City of Portland, Maine – Building or Use Permit Application 389 Congress Street, 04101, Tel: (207) 874-8703, FAX: 874-8716

BUILDING PERMIT REPORT

DATE: 31 Aug 98 ADDRESS: 364 Spring ST 061-F-001
REASON FOR PERMIT: To MAKE EXT. REZO
BUILDING OWNER: Chris Harte
CONTRACTOR: The Gilman Group
PERMIT APPLICANT:
USE GROUP R-3 BOCA 1996 CONSTRUCTION TYPE 53

Re: Porch Extension & Creation of Window Opening; 364 Spring Street

HARVE RESIDENCE
 364 SPRING STREET · PORTLAND
 6/4/98
 OPTION 3

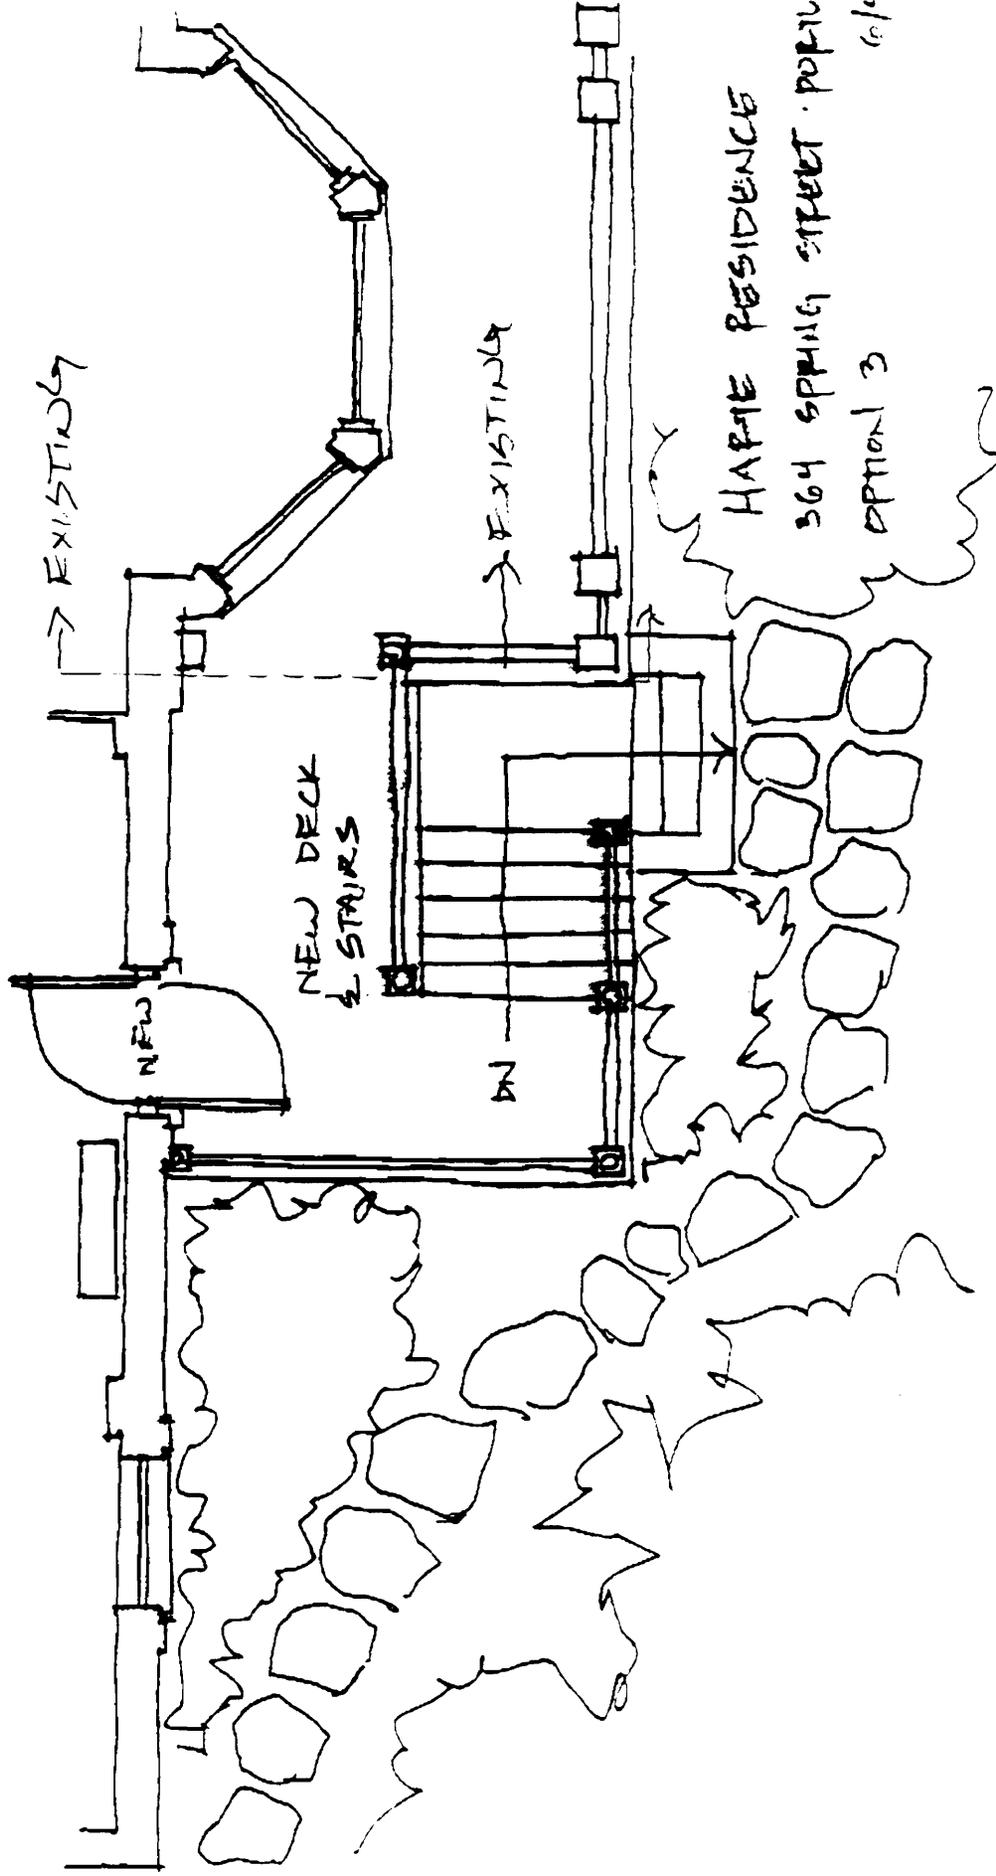
As you will recall, you requested consideration of three (3) alternative design schemes for the porch configuration. The Committee approved Options #3 and 2, but determined that Option #1 was not as compatible with the original architectural massing of the structure.

All improvements shall be carried out as shown on the revised plans and specifications distributed at the 6/17/98 meeting, except as modified to comply with the condition of approval described above. Changes to the approved plans and specifications and any additional work which may be undertaken must be reviewed and approved by this office prior to construction, alteration, or demolition. If, during the course of completing the approved work, conditions are encountered which prevent completing the approved work, or which require additional or alternative work, you must apply for and receive a Certificate of Appropriateness or Non-Applicability PRIOR to undertaking additional or alternative work.
